# SERVICE BULLETIN

## REPLACEMENT OF THE PROPELLER GEARBOX

### FOR SOME ROTAX® ENGINES TYPE 912/914 (SERIES)

#### SB-912-056 UL R1

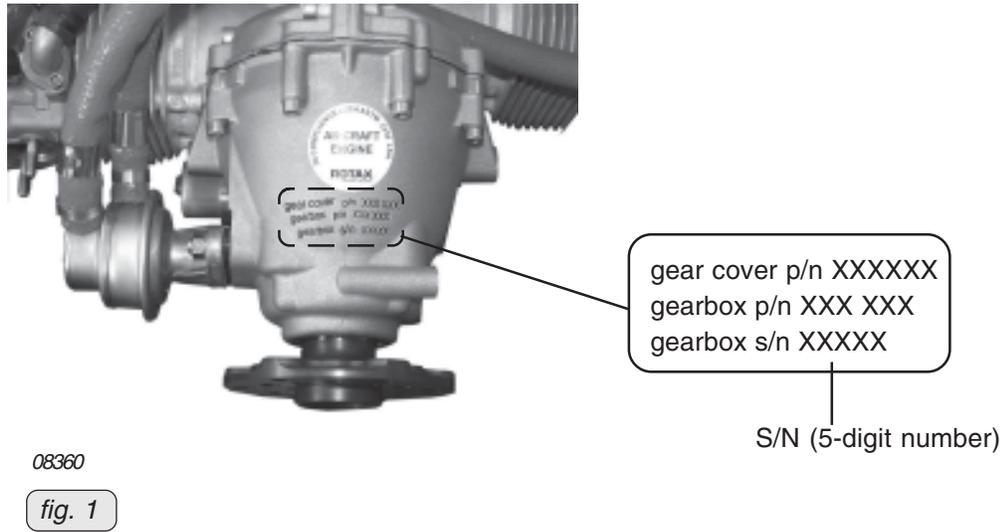
- ◆ NOTE: The respective serial number of the propeller gearbox is visible on the gearbox housing  
(see fig. 1)

◆ **NOTE:** The relevant serial number of the gearbox is visible on the gearbox housing (see fig.1).
